GOVERNMENT OF THE DISTRICT OF COLUMBIA
DEPARTMENT OF TRANSPORTATION

MEMORANDUM

SUBJECT: Zoning Commission Case No. 13-14A – McMillan Sand Filtration Parcel 2

Figure 1 - Site Design and Access (Source: Gorove/Slade)

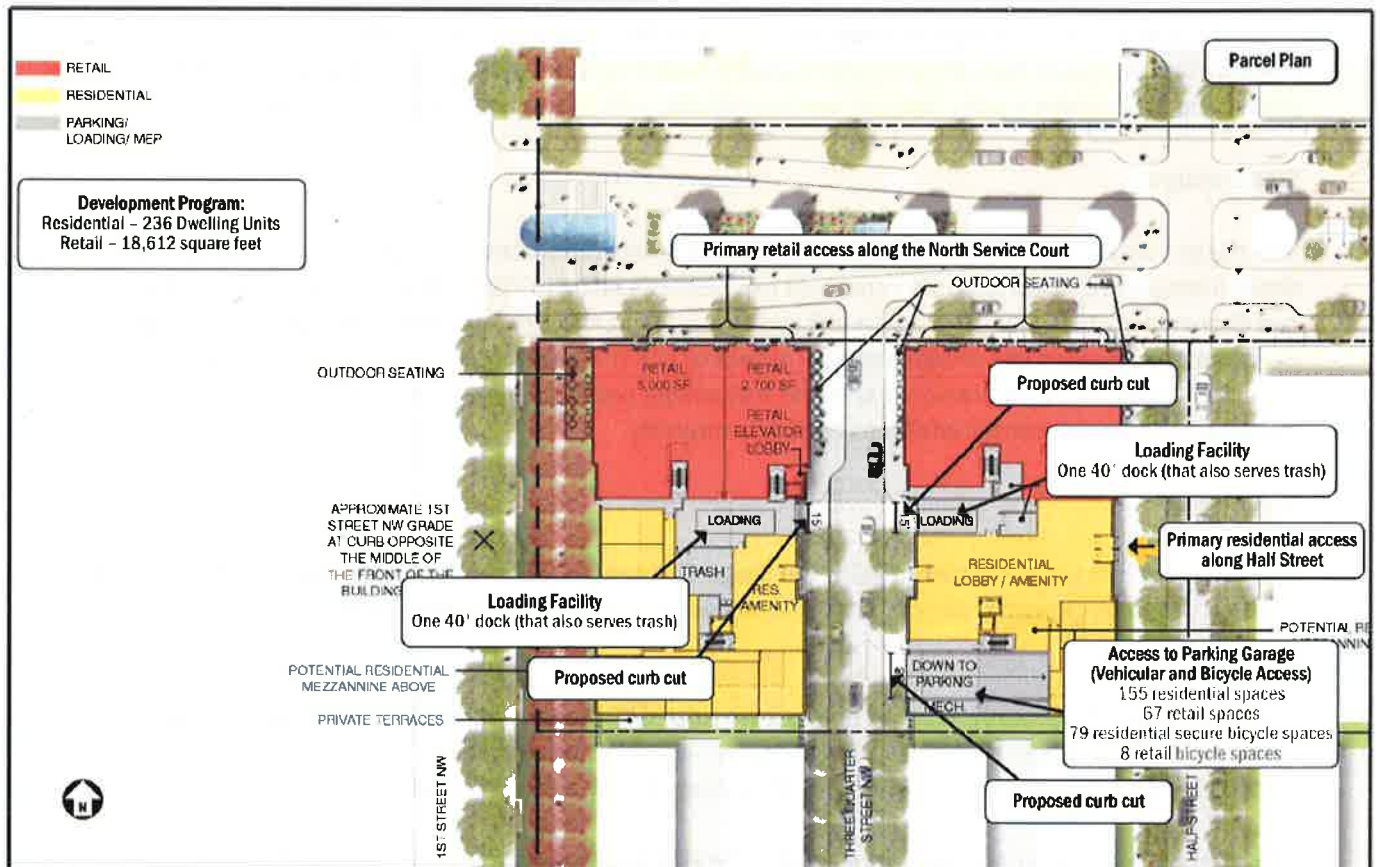
Site access points were not identified in the Stage 1 review but have been proposed as part of the Stage 2 plans. Vehicular, loading, bicycle, and trash access are proposed via Three-Quarter Street, which is a private street.

The parking garage access is located on the east side of Three-Quarter Street. There are two curb cuts leading to loading docks on Three-Quarter Street – one on the east side of the street serving a 30-foot loading berth and one on the west side of the street serving a 40-foot loading berth.

Loading facilities were not identified in the Stage 1 review but have been proposed as part of the Stage 2 plans. The two proposed loading berths require back-in/front-out movements. Although Three-Quarter Street is a private street and therefore not subject to DDOT standards that prohibit backing movements through public space, DDOT's preference would be to provide loading access with head-in/head-out movements.

Figure 2 Turning Maneuvers - SU-40 Inbound

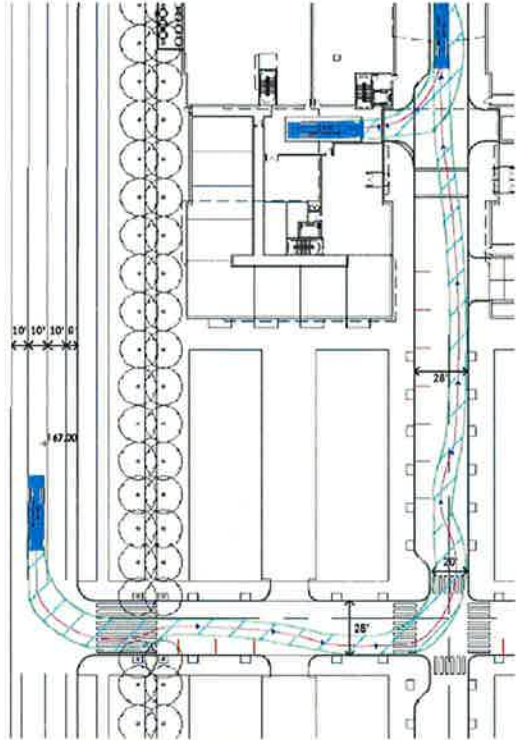
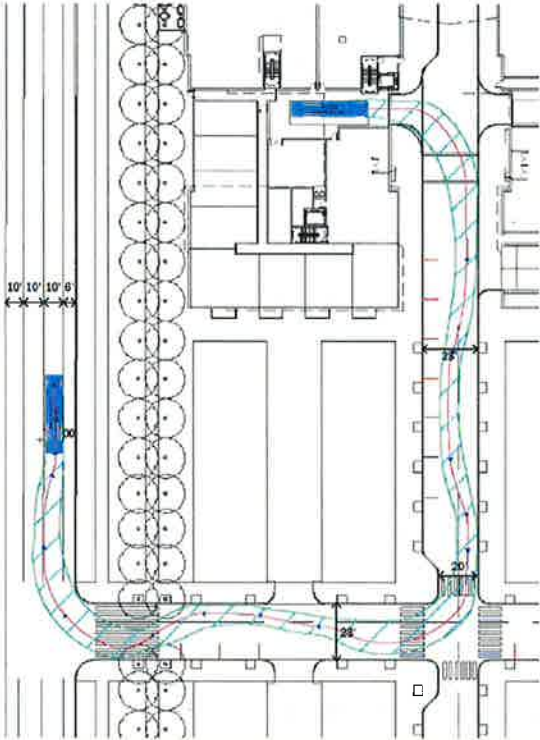
Truck routing and circulation diagrams including in the Applicant’s analysis revealed significant encroachment into opposite lanes of travel, particularly for SU-40 trucks. As shown in Figures 2 and 3, such maneuvers would block eastbound Evarts Street vehicular traffic attempting to access the site from First Street.

Figure 4 Turning Maneuvers - SU-40 Inbound (Revised)

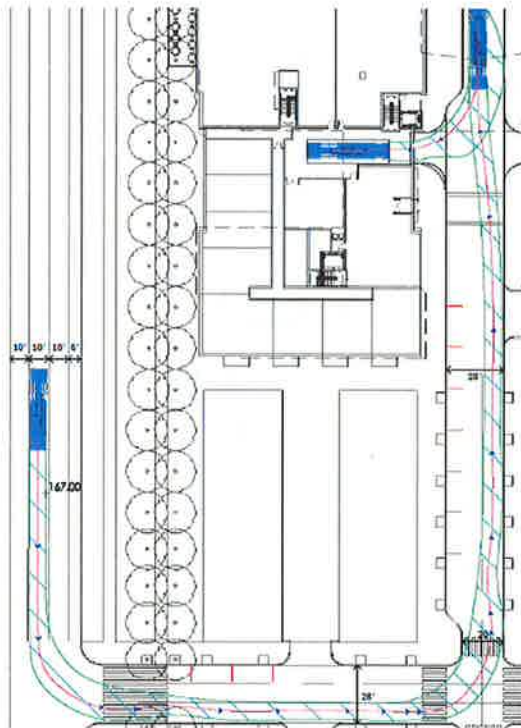
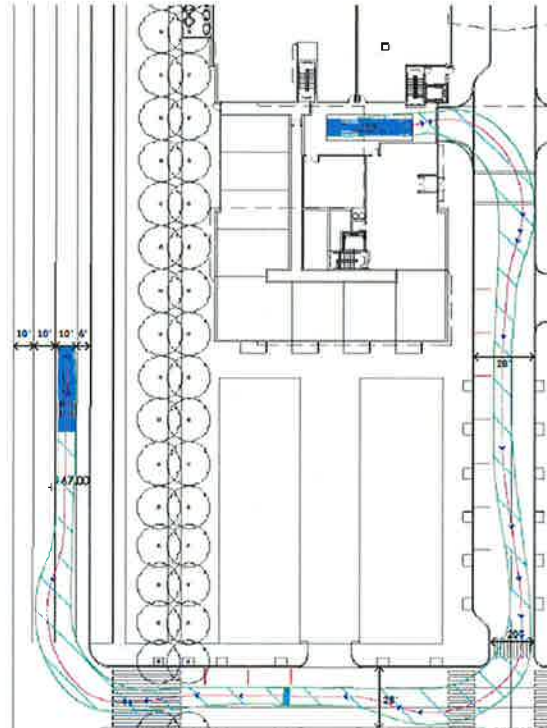
Flipping the on-street parking lane on Evarts from the south side of the street to the north side results in significantly less encroachment into the opposite lane from trucks and allows for improved vehicular operations, as shown in Figure 4 and 5.

The Applicant has expressed interest in this change but had not committed to it at the time this report was finalized.
